**AGENDA**  
**DESIGN REVIEW COMMITTEE**  
Lakeland City Hall, City Commission Chambers  
December 18, 2025  
immediately following the Historic Preservation Board Meeting

**HISTORIC PRESERVATION BOARD  
DESIGN REVIEW COMMITTEE  
STAFF REPORT  
December 18, 2025**

<b>Project #</b>	<b>HPB25-195</b>
<b>Project Type</b>	<b>Minor Exterior Alteration</b>
<b>Property Address; Historic Name</b>	<b>1926 Cherokee Trail / Fussell-Trohn House</b>
<b>Historic District; FMSF#</b>	<b>Beacon Hill; #PO02646</b>
<b>Owner/Applicant</b>	<b>Jeffrey and Megan Lazenby / ValuePro Remodeling &amp; Maintenance</b>
<b>Zoning; Future Land Use; Context District; SPI</b>	<b>Residential Medium; RA-1; Urban Neighborhood; None</b>
<b>Existing Use</b>	<b>Residential</b>
<b>Adjacent Properties</b>	<b>Residential</b>
<b>Previous Approvals</b>	<b>Window Replacement, 4/26/2018 (HPB18-066); Pool, 3/16/2022 (HPB22-059)</b>

<b>Project #</b>	<b>HPB25-218</b>
<b>Address; Historic Name</b>	<b>1056 South Boulevard; William and Myrtle Carpenter House (1924 CD)</b>
<b>Owner/Applicant</b>	<b>Alexa Lashkajani / Alan DeZayas, Avon Modular LLC</b>
<b>Project Type</b>	<b>Building Addition, Replacement Windows,</b>
<b>Historic Di

CHEROKEE TR.  
1926

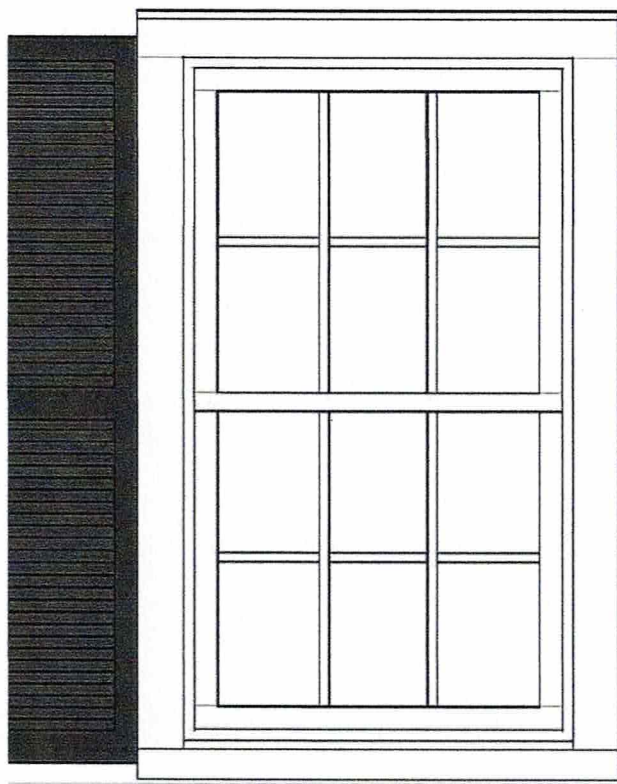
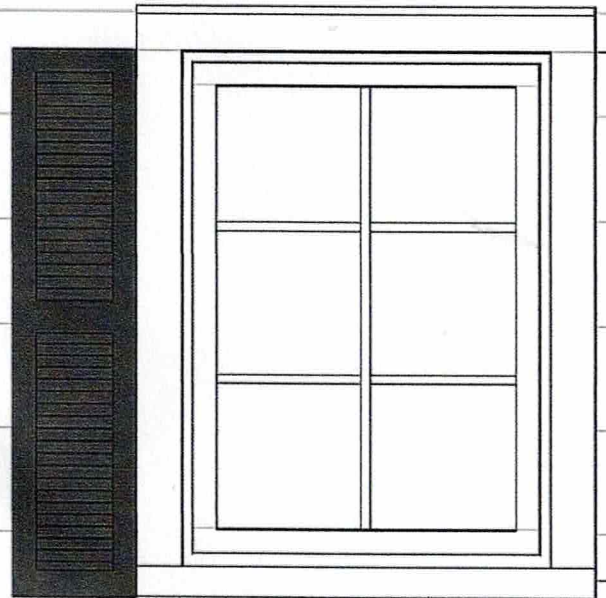
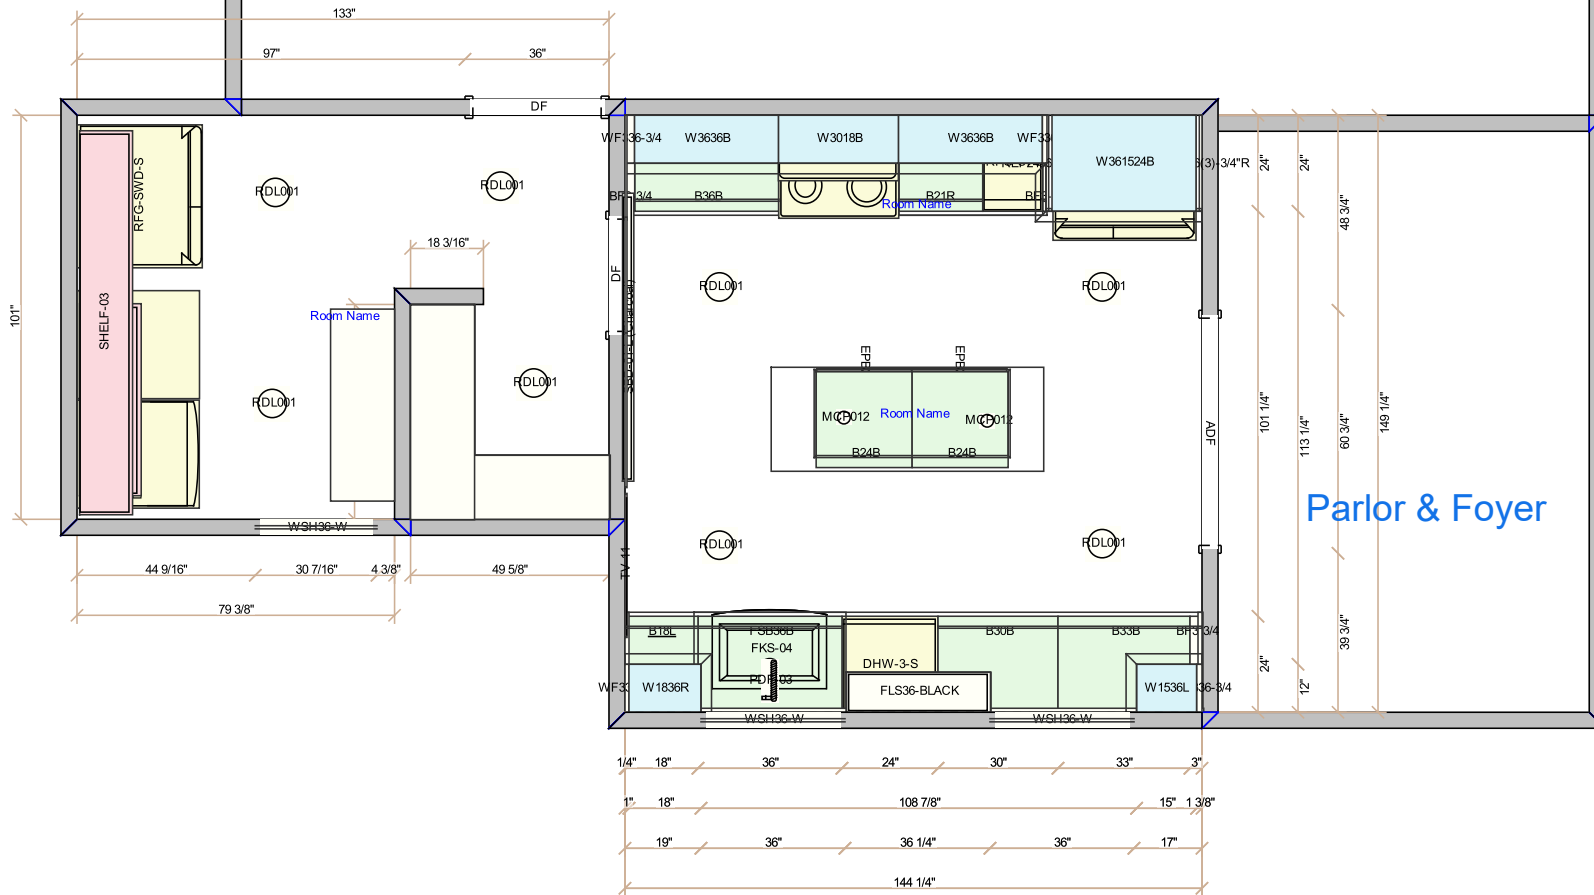
The request involves resizing two windows on the front façade to facilitate a kitchen remodel, which will relocate the kitchen into the current dining room. The existing kitchen area will become a pantry/laundry room. To accommodate new kitchen cabinets and counters, the window openings currently located in the dining room will need to be shortened. The existing window openings are 36 inches wide by 53 inches tall, but are requested to be shortened to 32 or 36 inches tall. The existing window headers will remain at the same location; new window sills and side casings designed to match the existing will be installed.

While resizing window openings on a front façade is not recommended typically by the Design Guidelines, staff finds this request is appropriate given the asymmetrical composition of the house and the fact that the existing windows are not historic. However, to maintain an appearance and scale similar to the existing kitchen window, the height of the new window openings should not be less than 36 inches tall.

Staff recommends approval for the request, with the condition that the height of the new window openings is not less than 36 inches tall.
